GARAGE ADDITION PROPOSAL  
**2903 W MCKINLEY**

**GARAGE  
ADDITION  
PROPOSAL**

HPC meeting date: 11/4/2019  
Ald. Robert Bauman District: 4  
Staff reviewer: Tim Askin  
PTS #114852 CCF #191001  
Property

Milwaukee Historic Preservation Commission  
Staff Report

## LOCATION

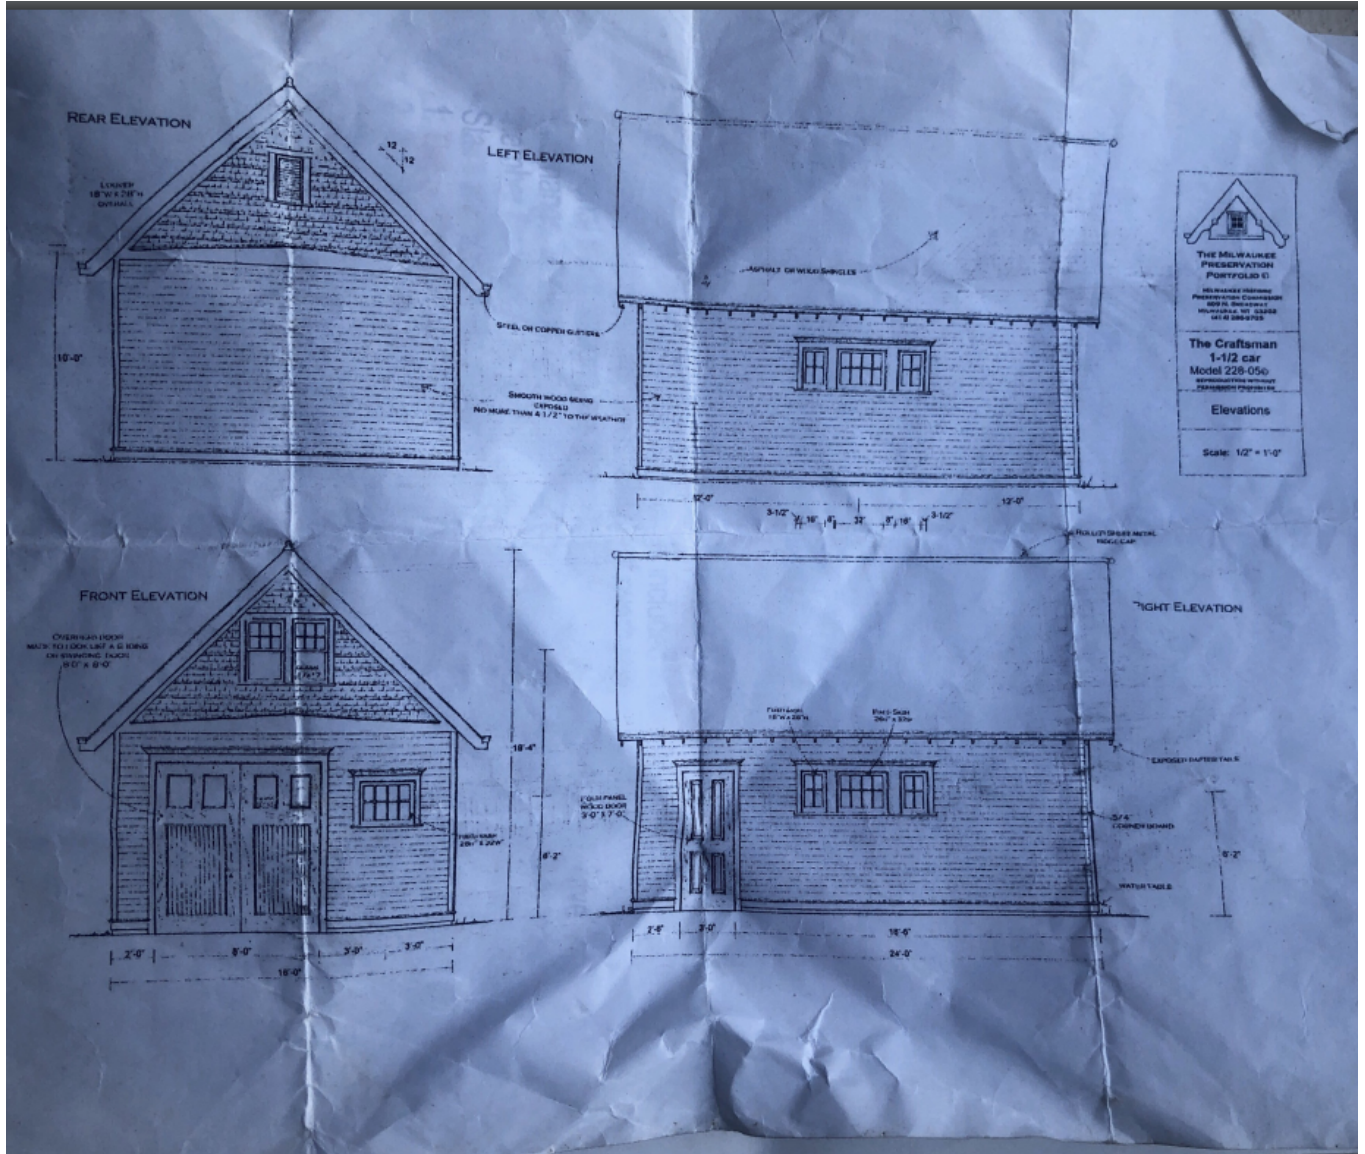
The application does not specify an exact design or location. The location appears appropriate, but as a survey is required for a building permit for a garage, we have generally required it ourselves for new garages. However, attached garages have generally not been allowed in historic districts and the lot may be too small for a detached garage.

It will impossible to meet the 10' rear setback required for an attached garage. It will be difficult to meet the 18" setback for a detached garage.

HOLD for referral to Plan Examination and Board of Zoning Appeals for siting and fire-rating issues.

**MENARDS®**  
Design-It™  
Garage

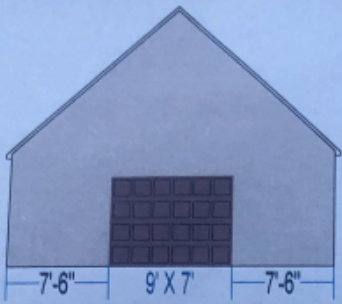
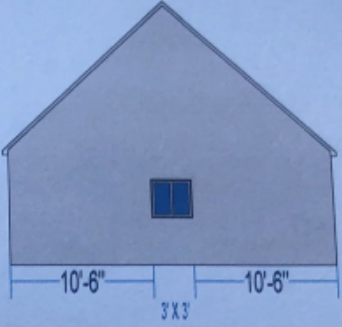
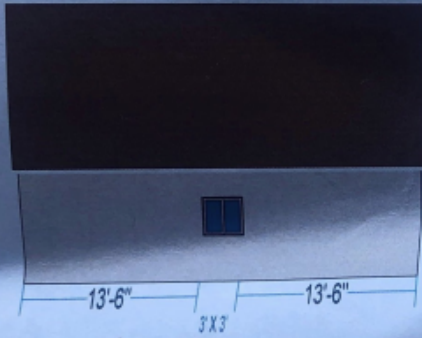
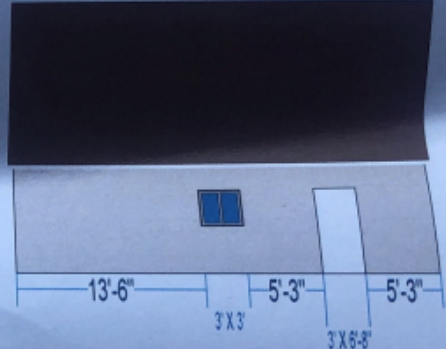
This application is for a garage addition. The plans provided indicate a front gable design with minimal designed articulation. The estimates provided indicate that the garage will be clad in 4" vinyl siding, feature vinyl soffit and fascia, three vinyl window units, a single steel service door, and a steel overhead door. The elevations included with the application package indicate interest in a craftsman style garage. A collaged image indicates a garage in this style as well, but the applicant specified in their description that the image "does not reflect an exact color scheme or design."

Three designs are included. One is presumed not to be the design intention. The other two, borrowed from HPC files would be acceptable with complete construction plans.

Materials proposed vinyl siding and vinyl windows. These materials have not been accepted by the Commission for any new construction because of their inherent dissimilarity to historic materials. Vinyl siding will also complicate fire separation between the buildings. Very few vinyl siding products are approved for used in 2 hour fire-rated assemblies. It is not known what can be used in a 3/4 hour assembly (<http://productspec.ul.com/document.php?id=BXUV.U301>). Windows of any material will not be feasible on any side of a proposed garage within 10' of another structure because of fire rating requirements (SPS 321.08).

Or DENY based on materials.
